PLAN & PROFILE
MONTE VISTA DRIVE
TRACT 2373

PLAN & PROFILE
CHAPALA DRIVE
TRACT 2373

APPROVED BY: <i>[Signature]</i>	J. F. DAVIDSON, CIVIL ENGINEER	PLAN & PROFILE LOS ALTOS COURT STORM DRAIN TRACT 2373	3 OF 2 SHEETS No. R-592
DATE: 11/8/62	3426 TENTH STREET RIVERSIDE, CALIFORNIA		
APPROVED BY:	SCALE: HORIZ. 1"=4' VERT. 1"=4'	BENCH MARK: CITY 3.00 S.E. 1/4 of Sec. 4 of Chicago Ave 100' E. from N.E. corner of Chicago Ave & South St. E.L. 384.31	
DATE:	DATE DEC. 1960	W.O. 10313 FOR: SUN G.O.D., INC.	F.B. 716-1

PLAN & PROFILE
LE CONTE DRIVE
TRACT 2373
 OF 2 SHEETS

PLAN & PROFILE
 LA SUBIDA COURT
 LA MESITA COURT
 TRACT 2873
 5 OF 2 SHEETS
 NOV-62

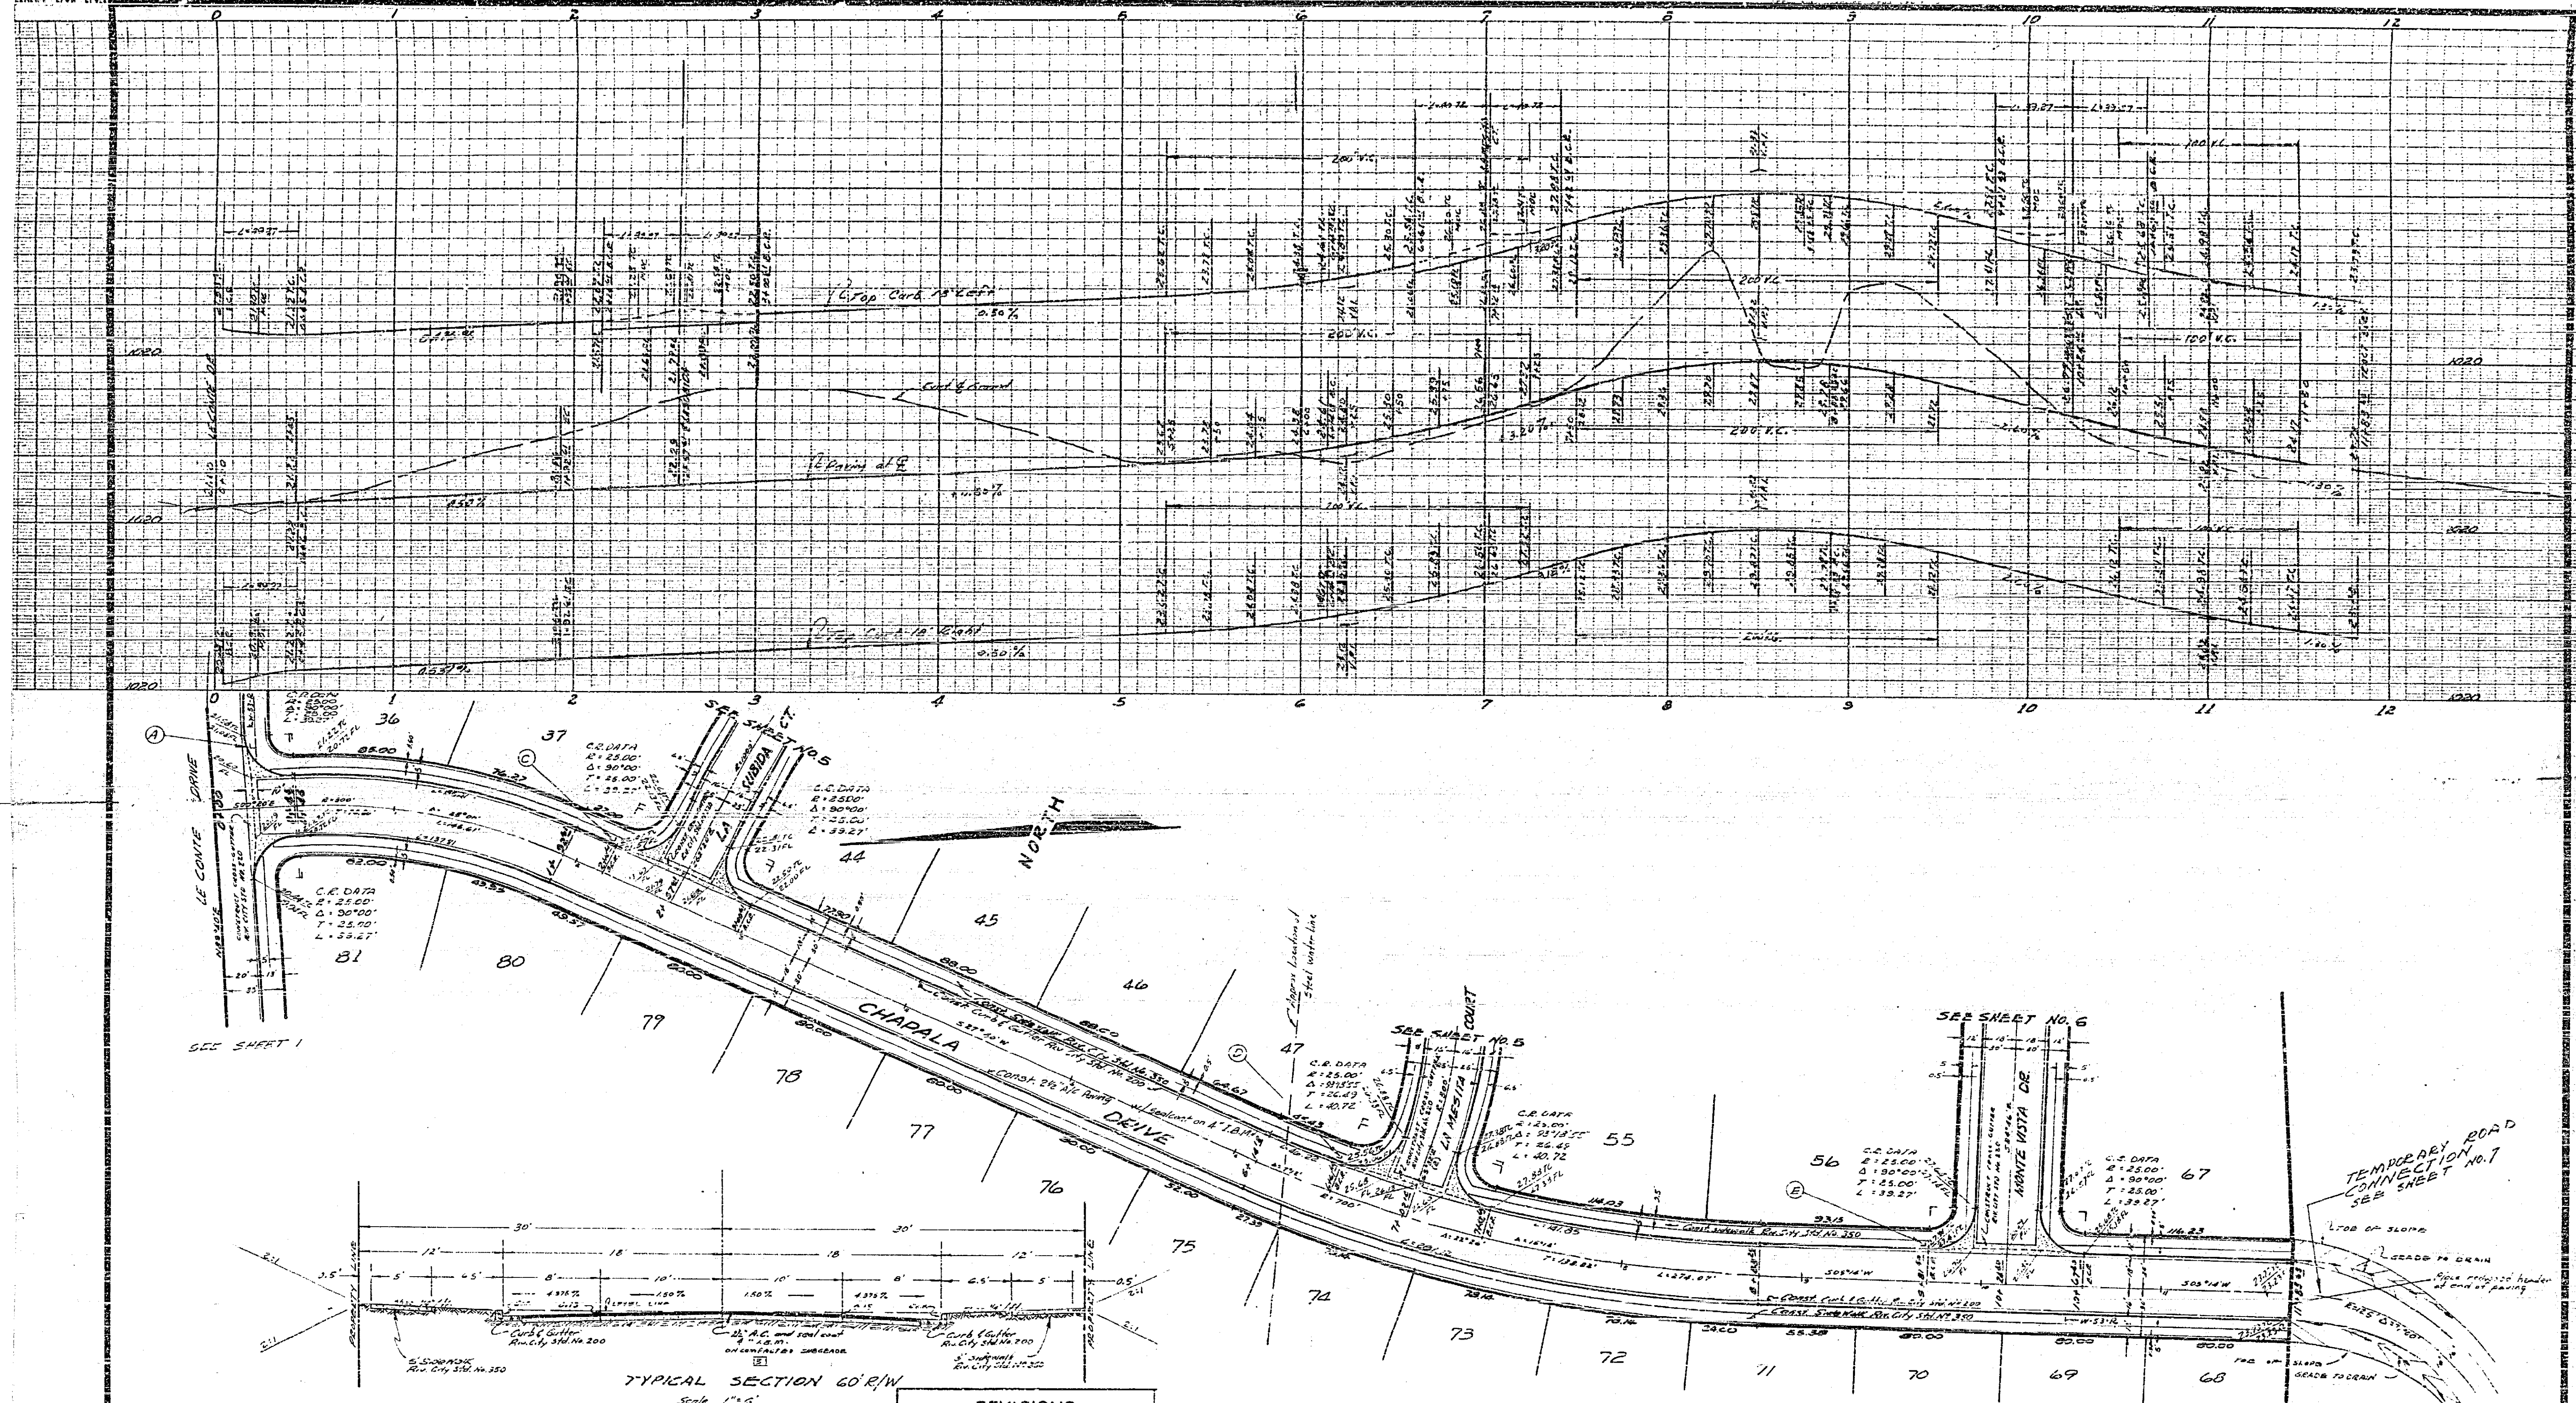
REVISIONS		
MARK	DATE	DESCRIPTION
*	8-17-62	Add drop line as shown removed from 37 to 38 & L.R. Director of Public Works working 2:15
**	7-3-63	After review approved for outlet structure only. See plan. Add storm line as shown approved. D.P.W. 12-15-63 Director of Public Works

Remove curb at end of pipe
 as shown in elevation
 and make smooth transition
 of pipe at curb over structure.
 Also show that include the storm drain between
 lots 50 & 51 outside of street right of way.

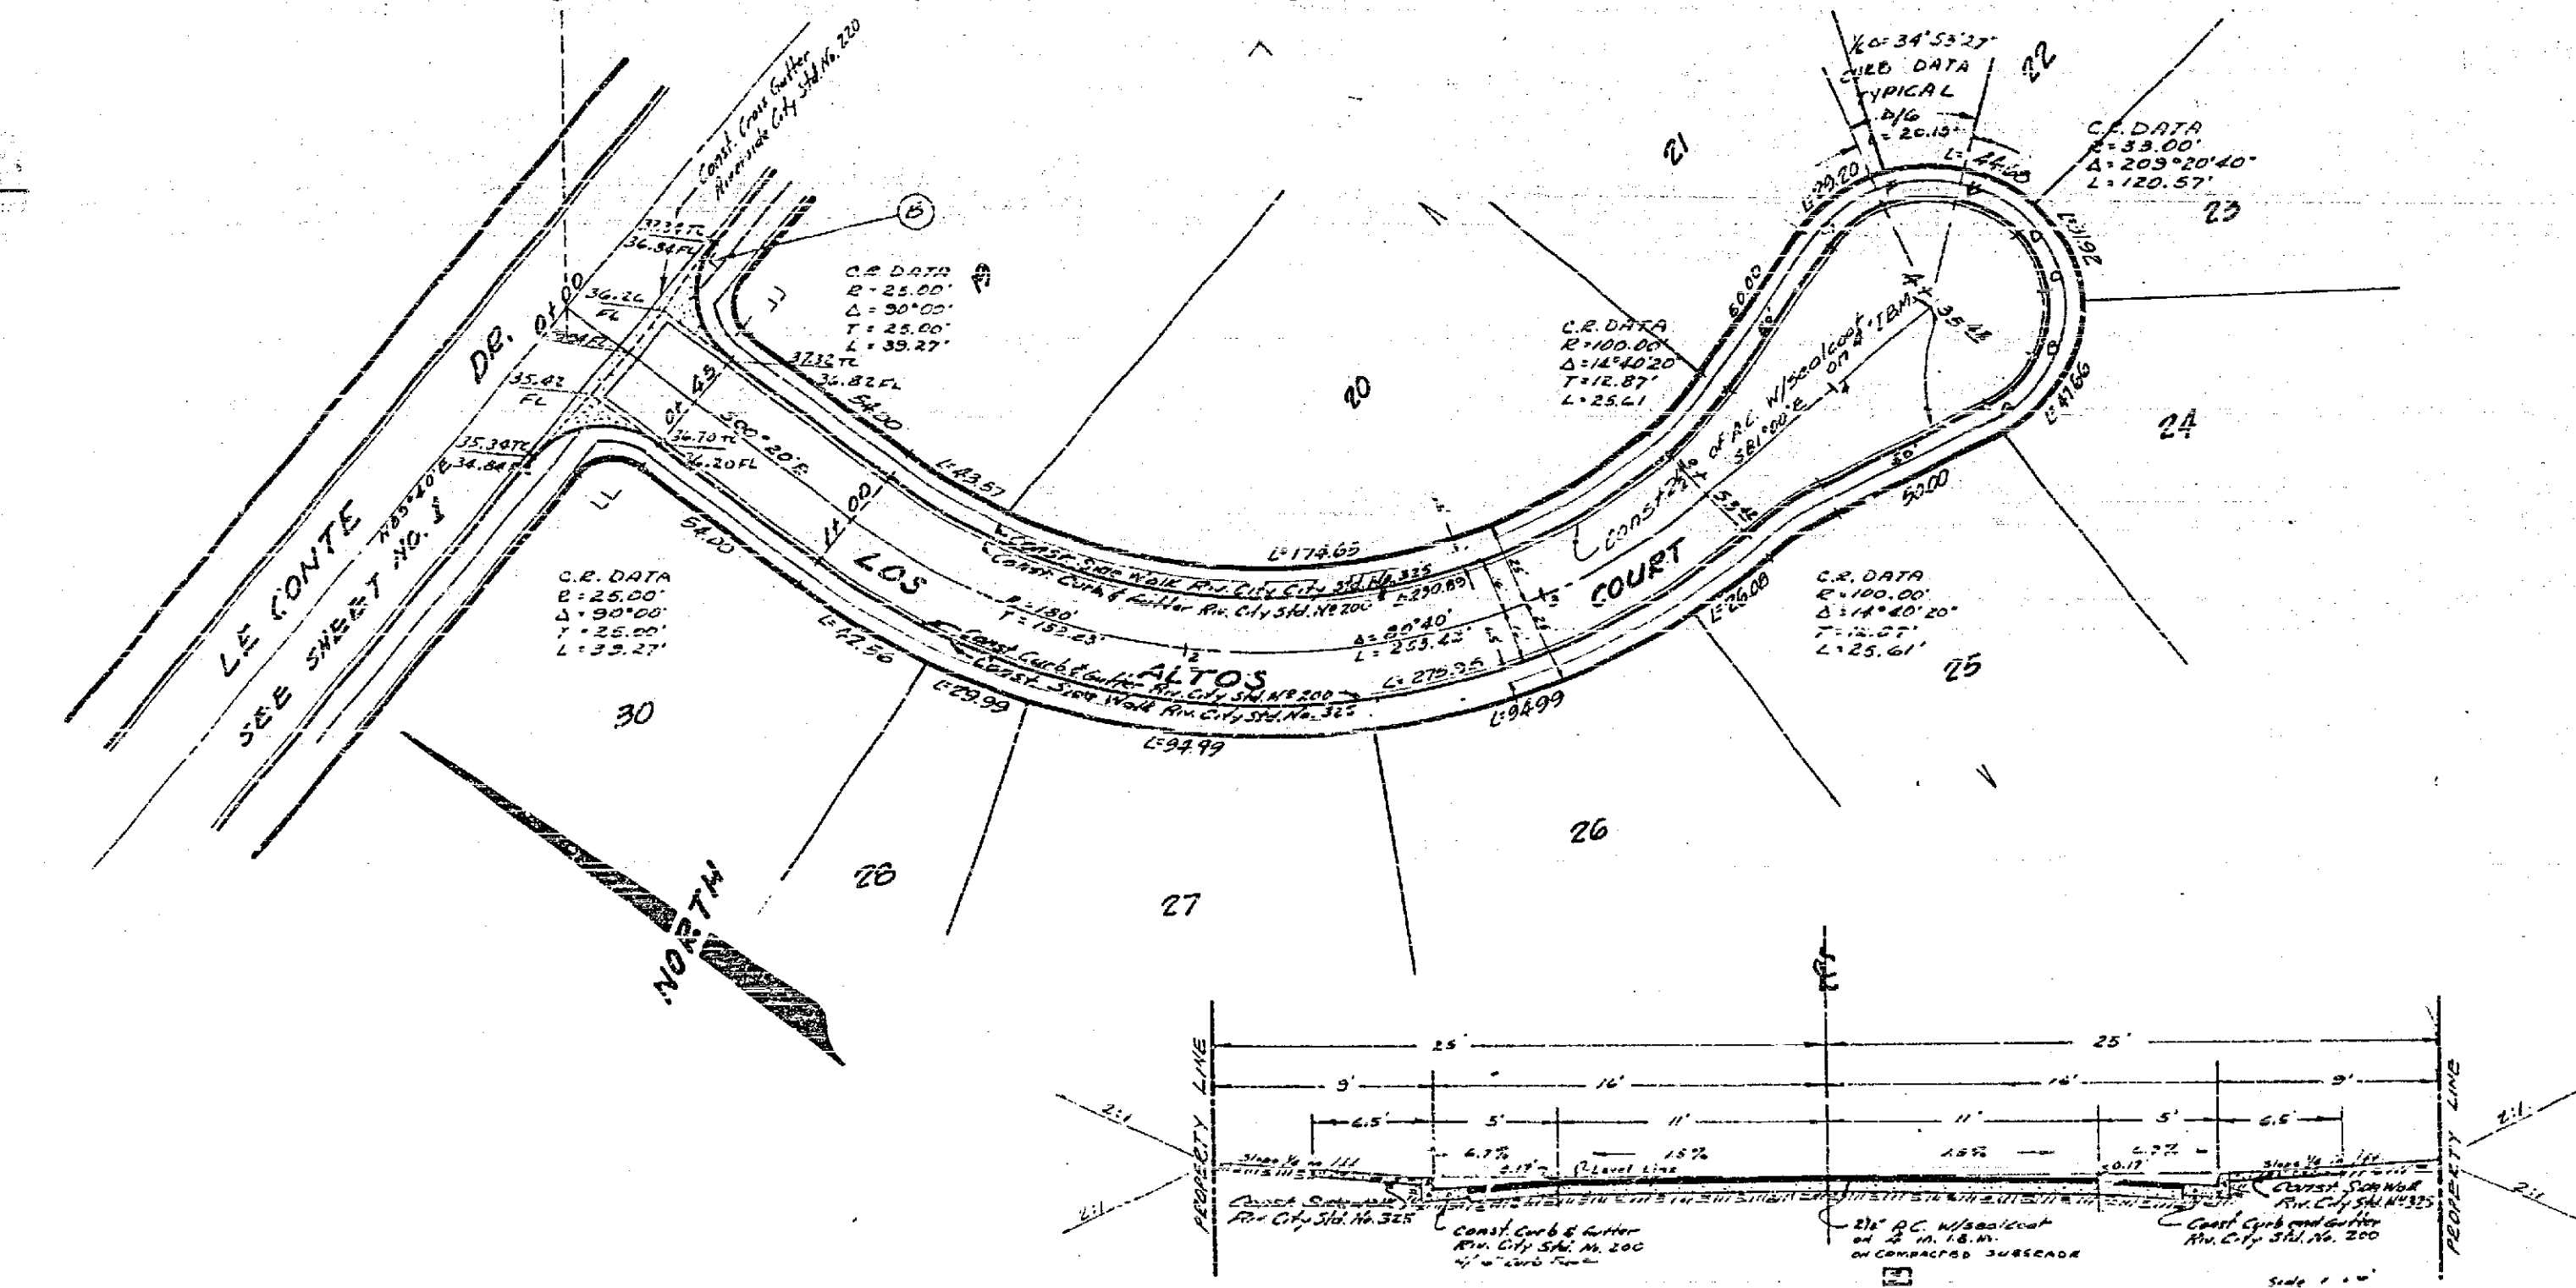
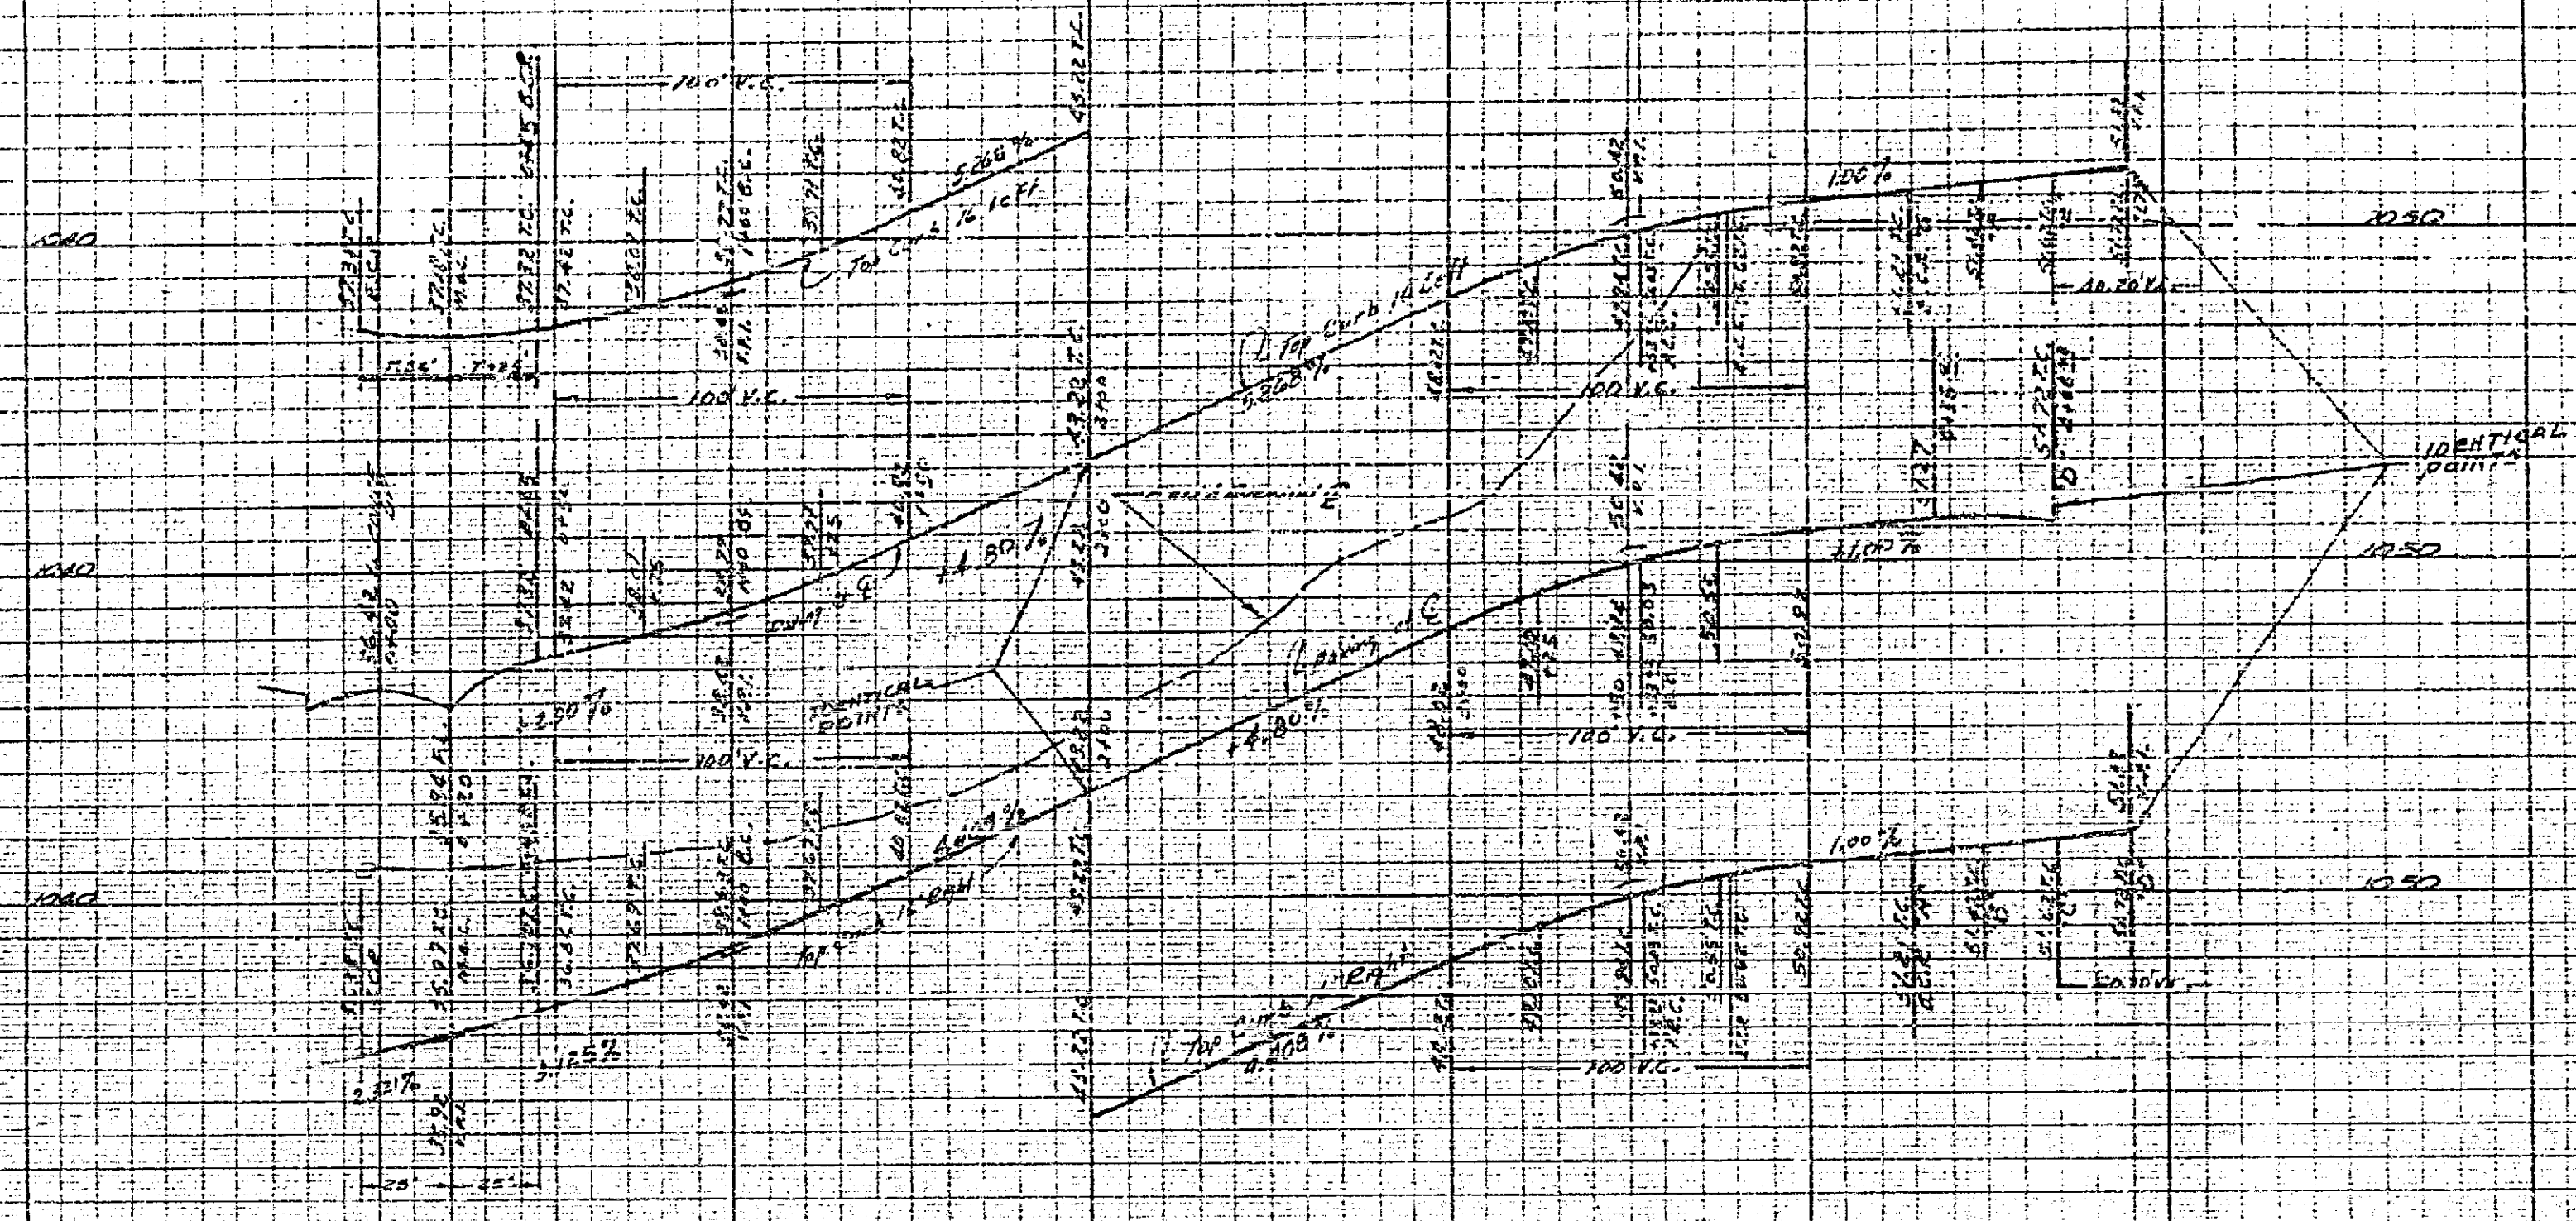
REVISIONS		
MARK	DATE	DESCRIPTION
1	11-29-62	Changed I.R.M. from 12" to 8"
